# Access Compliance Report

## Public Rights-of-Way

Intersection ID: 49133	Main Street: EWERT_CUT_LN	Cross Street: AMBER_LEIGH_WAY_DR	Location: NE
ADA ID: 3B541839C7B6	Ramp Type: Perp	Initial Pass/Fail: Fail	Overall Compliance: No
Severity Score: 10			
Codes/Mitigation Info/Possible Solution		Field Measurements/Component Compliance

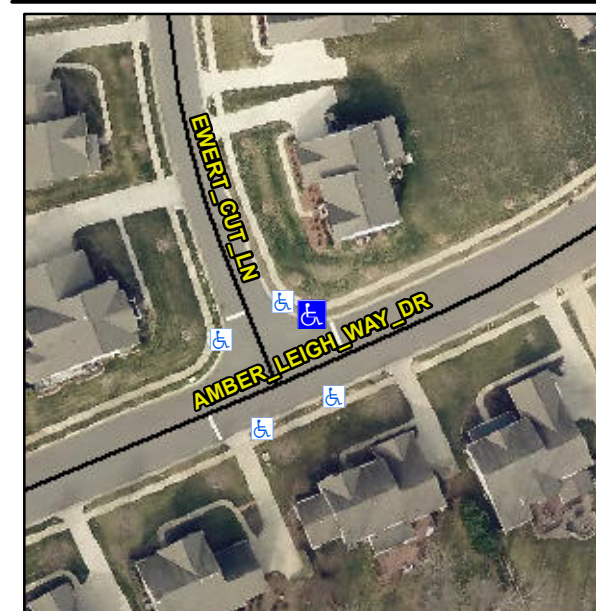
**Not Found, R304.5.1, R304.5.3**

Compliance	Description	Data	Compliance	Description	Data
N/A	Ramp Length (in)	48.0	Yes	Ramp Slope (%)	7.4
No	Ramp Width (in)	46.5	No	Ramp XSlope (%)	4.2
N/A	Flare Type LT	N/A	N/A	Flare Type RT	N/A
N/A	Flare Slope LT (%)	N/A	N/A	Flare Slope RT (%)	N/A
N/A	Flare Traversable LT?	N/A	N/A	Flare Traversable RT?	N/A
N/A	Landing Length (in)	N/A	N/A	DWS Provided?	N/A
N/A	Landing Width (in)	N/A	N/A	DWS Contrast?	N/A
N/A	Landing Slope (%)	N/A	N/A	DWS Length (in)	N/A
N/A	Landing X Slope (%)	N/A	N/A	DWS Full Width?	N/A
N/A	Landing Curb? (Y/N)	N/A	N/A	DWS Offset (in)	N/A
N/A	Shared Landing?	N/A			
N/A	Gutter Ponding?	N/A	N/A	Gutter Slope (%)	N/A
N/A	Gutter Lip Ht (in)	N/A	N/A	Gutter X Slope (%)	N/A
N/A	Painted X Walk1?	No	N/A	Painted X Walk2?	N/A
	X Walk 1 Direction	To S		X Walk 2 Direction	N/A
N/A	X Walk 1 Width (in)	N/A	N/A	X Walk 2 Width (in)	N/A
	X Walk 1 Slope (%)	2.6		X Walk 2 Slope (%)	N/A
	X Walk 1 X Slope (%)	1.5		X Walk 2 X Slope (%)	N/A

**Remove & Replace Entire Ramp.**
